Serial No:10/688053
Docket No: Rennich-001

AMENDMENT IN THE DRAWINGS

FIG. 4

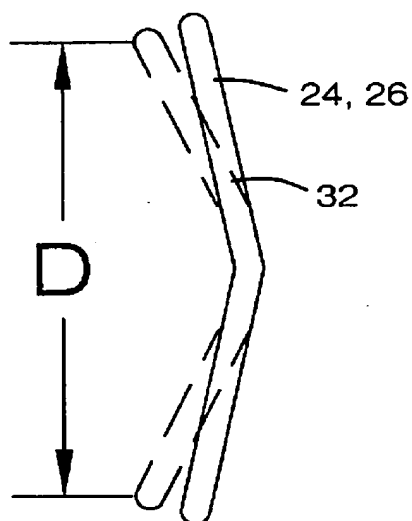
Examiner, on examiner's action page 2, has requested the addition of a perspective view of the alternate embodiment of pins 24 and 26 as illustrated in Figure 4. A replacement sheet of drawings including an additional Figure 5 is being submitted herewith in accordance with 37 CFR 1.121(d). Figure 5, is a perspective view of the alternate embodiment of pins 24 and 26 illustrating the bridge portion 32 bent at a mid point.
